**Packet Guide**  
**City of Charlottesville**  
**Board of Architectural Review**  
**Regular Meeting**  
**February 18, 2026 5:30 p.m.**  
**Hybrid Meeting (In-person at Council Chamber and virtual via Zoom)**

2. **Certificate of Appropriateness Application**

BAR # HST26-0001

Project: Window replacements

Existing

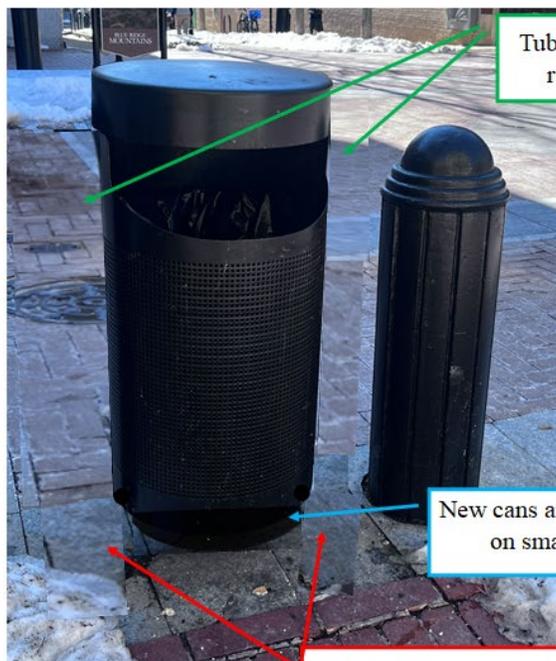
- The current unit and the recommended replacement are very similar in appearance, with the primary difference being the absence of tubular supports on the replacement unit.
- Unit dimensions are comparable:
  - Current unit: 47” H × 23.75” D × 27” W
  - Recommended unit: 42” H × 20.5” D (width not provided in the specification sheet)
- Replacement units will be ordered in the same finish, Gloss Black.
- Replacement units will be mounted in the existing locations with no changes to servicing procedures.
- The current units require clearance to allow for emptying, whereas the recommended units utilize a hinged lid, eliminating impacts to pedestrian circulation.
- The perforated patterns of the new unit match the preexisting unit
- The trash receptacle openings are an exact match
- The trash receptacles referenced are not historic features and are not original to Halprin’s design.
